Concerned Products:	Customer Notification		Date: Aug. 30, 1999
μPD789405/6/7 μPD789415/6/7 μPD78F9418			Bug Report
Jan. 28th, 98		Doc. No.: TPS-LE-B-S401	
1 st revision	: June 4th, 98	Doc. No.: TPS-LE-B-S401	
2 nd revision	: Nov. 18th, 98	Doc. No.: TPS-LE-B-S401-1	
3 rd revision	: Aug. 30th, 99	Doc. No.: TPS-LE-B-S401-2

(A) BUG LIST

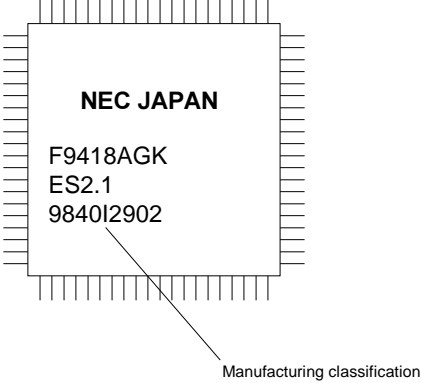
Bug No.	Outline	Description		
2	Read data from UART	<p>Details</p> <p>Do not read the RXB register immediately after occurrence of a reception interrupt, because an overrun error may occur.</p> <p>Instead of this, wait several clock cycles as indicated in the "Clock Count Until RXB Read" table shown below, before reading RXB register!</p>		
		Clock Count Until RXB Read		
		BRGC setting	Transfer rate @ 4.9152 MHz	High speed PCCI = 0
		00H	153.6Kbps	0
		10H	76.8Kbps	0
		20H	38.4Kbps	0
		30H	19.2Kbps	7
		40H	9.6Kbps	23
		50H	4.8Kbps	55
		60H	2.4Kbps	119
		70H	1.2Kbps	247
		80H	<p>In the case of an external clock, make sure that the waiting time is satisfying the following expression:</p> $EXCL1(Hz) > f_{CPU}(Hz) / (9 \text{ clocks} + X \text{ clocks})$ <p>The external clock frequency EXCL1 is "the transfer rate multiplied by 2", f_{CPU} is the CPU's operating frequency. Nine clocks result because the interrupt processing is starting one clock after the occurrence of the interrupt and eight clocks are used for the interrupt processing. "X clocks" refers to the clock count until the reading is over. The timing of reading the RXB register in the interrupt routine varies from one application to another.</p> <p>Example, the CPU operates at 1MHz by inputting 4.8KHz clocks from EXCK1:</p> $4.8KHz > 1MHz / (9 + X)$ $X > (1MHz / 4.8KHz) - 9$ $X > 199.3$ <p>Accordingly, reading the RXB register in the interrupt routine must be performed after 200 clocks.</p>

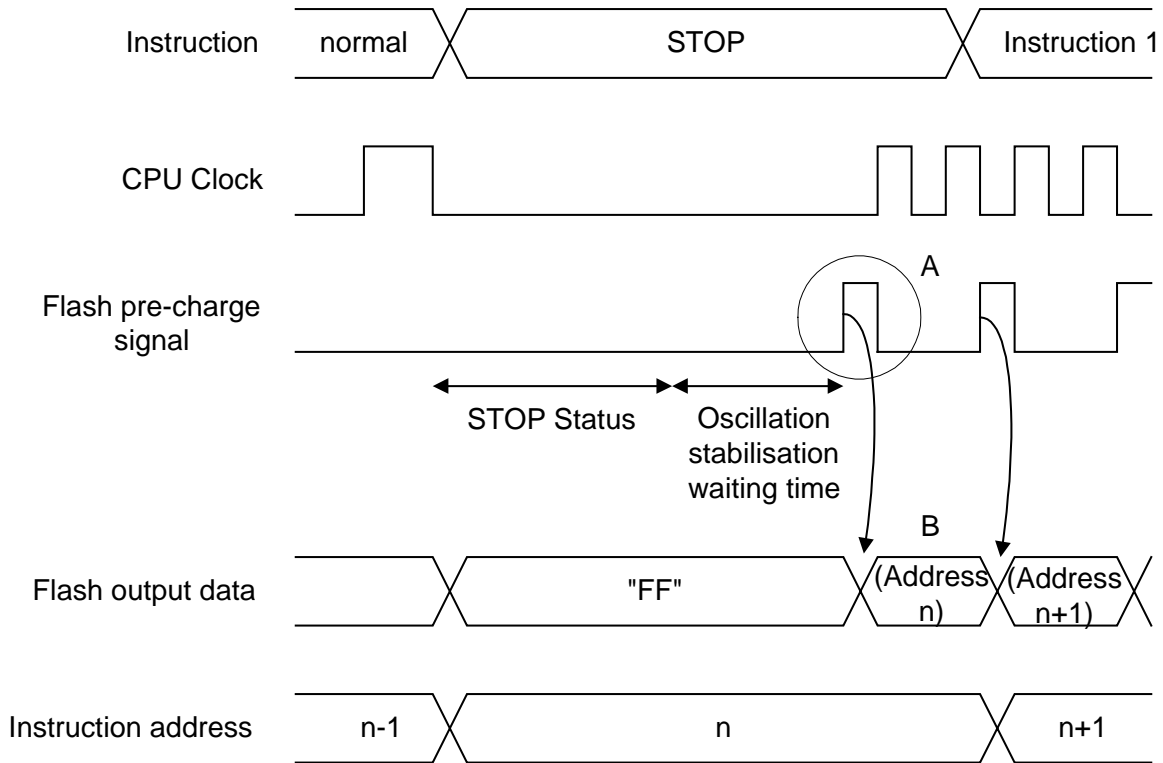
Bug No.	Outline	Description
6	Stop mode release restrictions for flash device	<p>Detail:</p> <p>To use the flash device in stop mode, be sure to release the stop mode with a vector interrupt, not only with the request flag. For a detailed restriction description see the Attachment 1.</p> <p>An interrupt, which does not jump to a vector after stop mode is released results in runover after STOP is released.</p>
